Potential Change Order Request

1318017 - Belmont Middle and High School

Potential Change Order: 672 Date: 5/18/2022

RFI 1633 Screen Wall Sheathing Area D-F

RFI #1633: Screen Wall Sheathing Area D-F

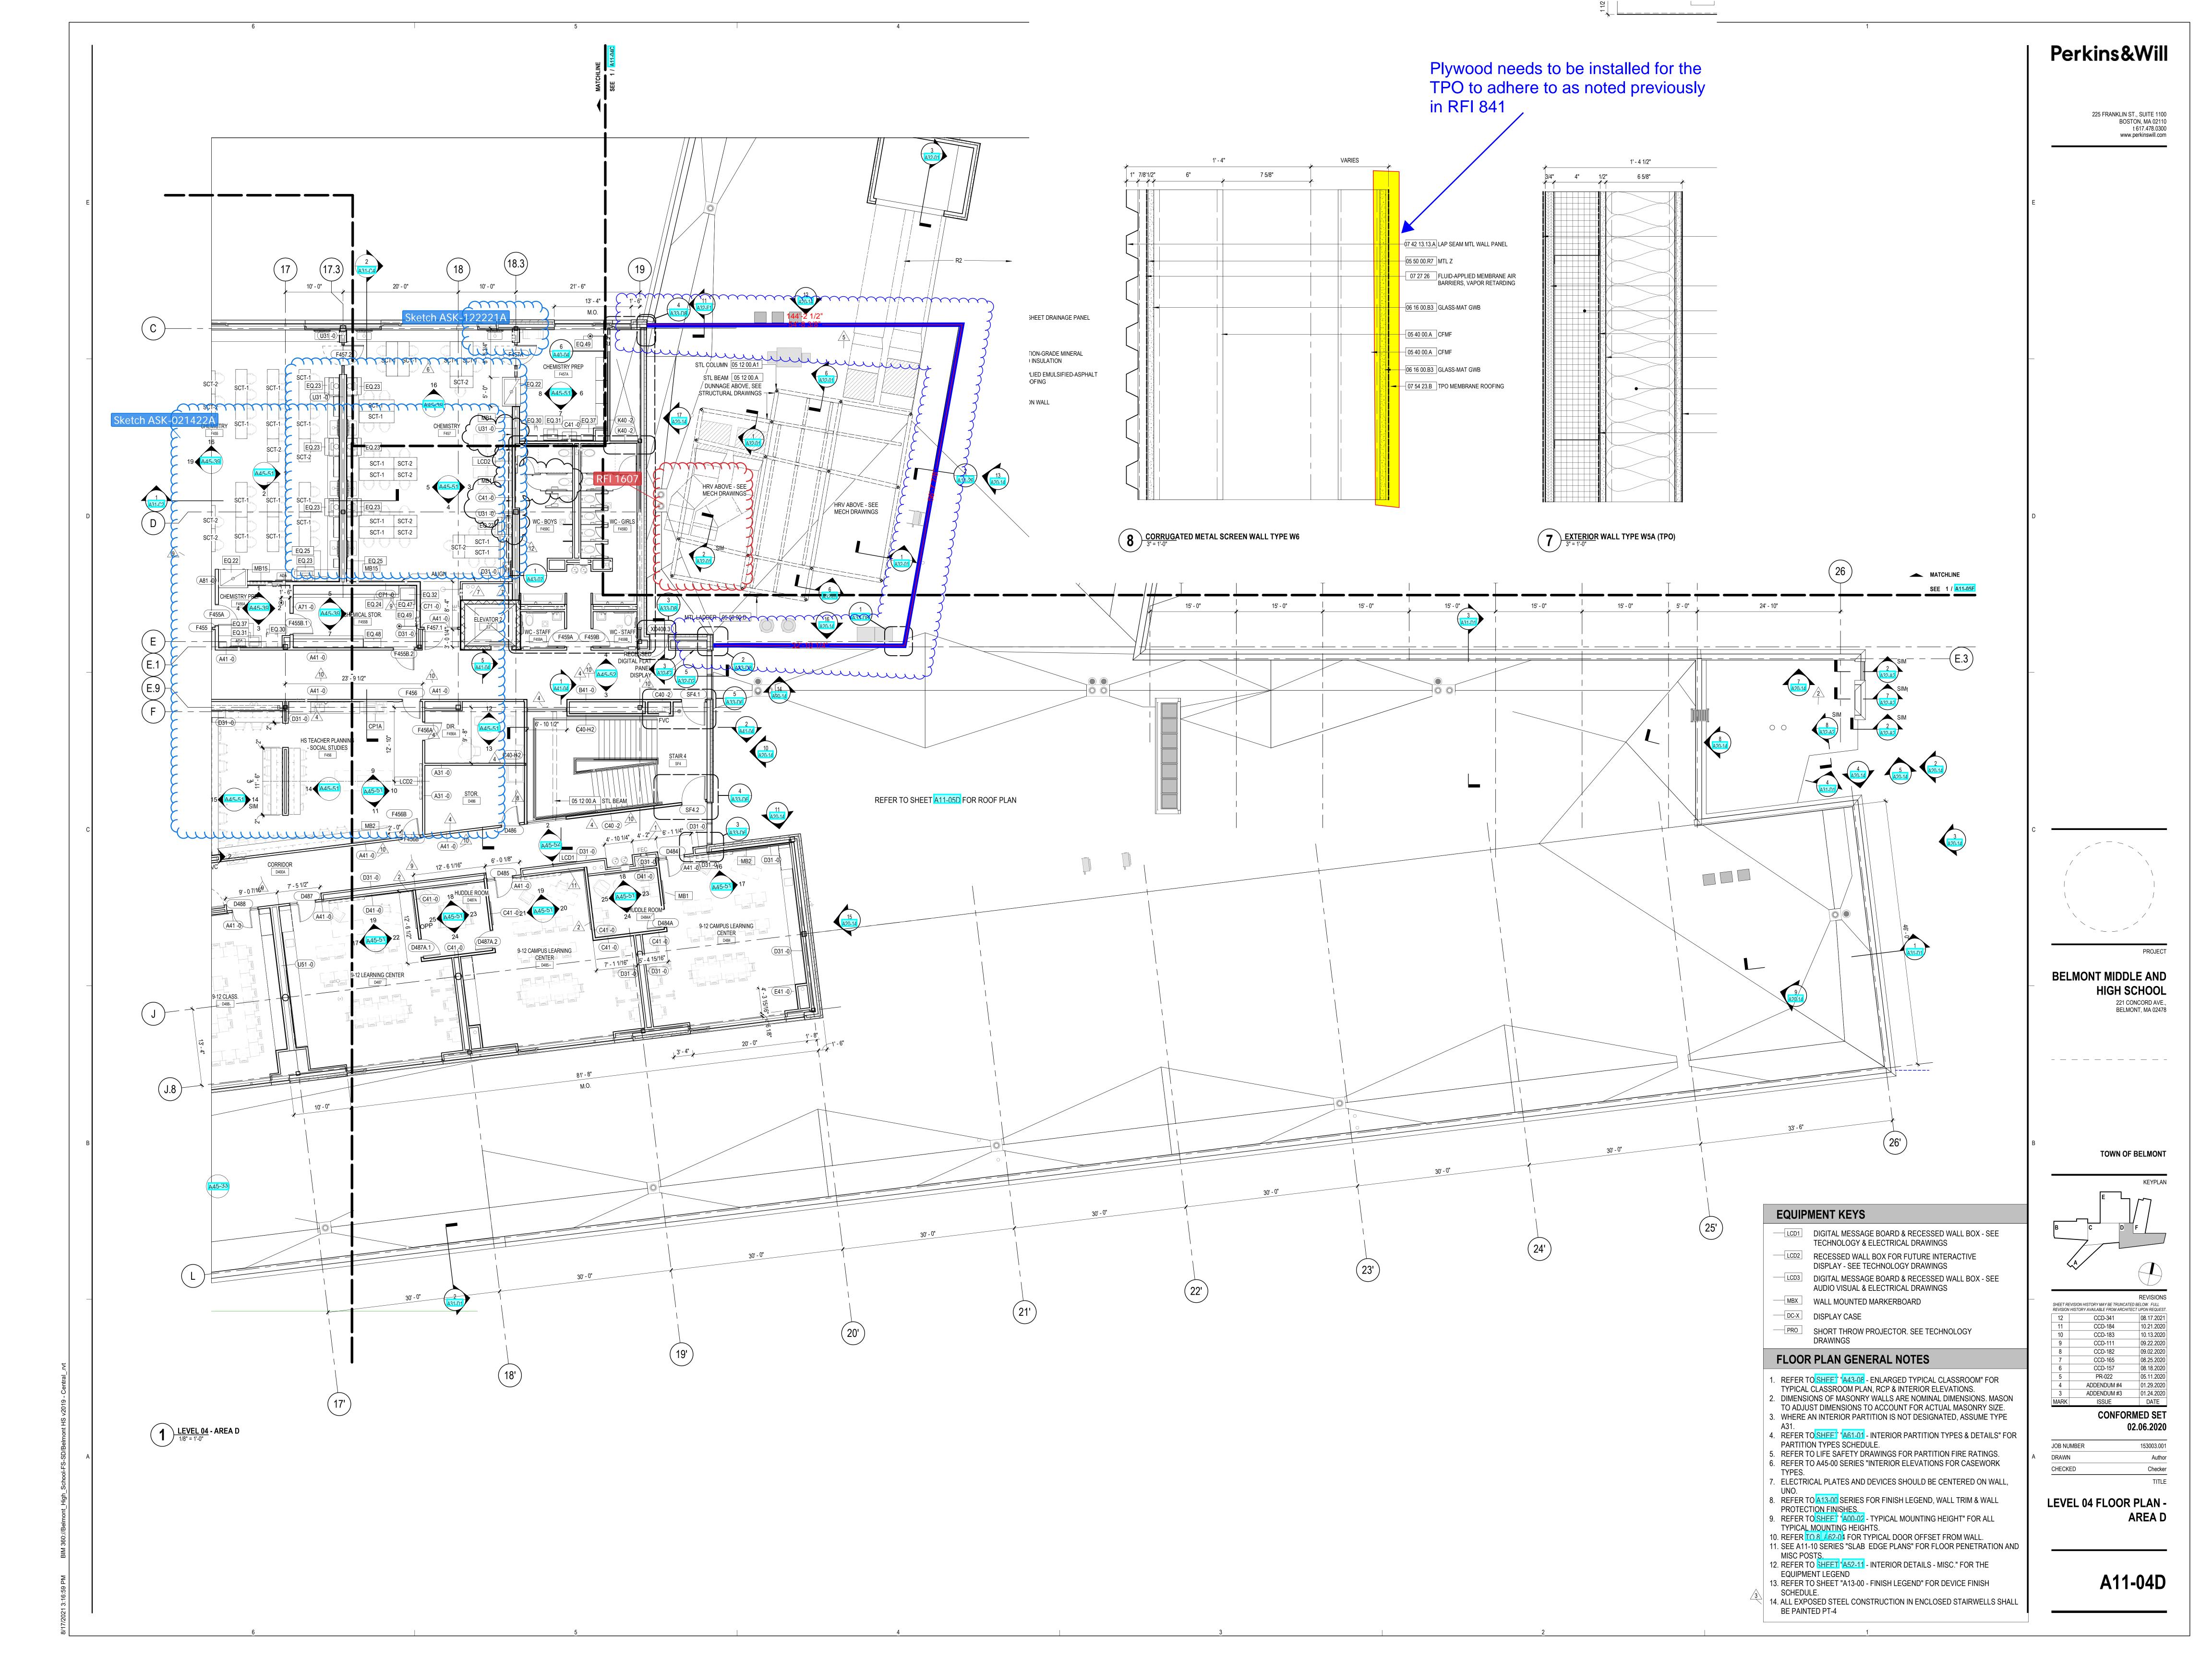
As noted in RFI 841 for Phase 1, the screen wall for Phase 2 will require plywood to be installed over the sheathing in order for the TPO to adhere to it. Please see the attached drawing outlining the areas required as well as RFI 841 for reference.

The glass mat sheathing can be substituted for plywood as noted.
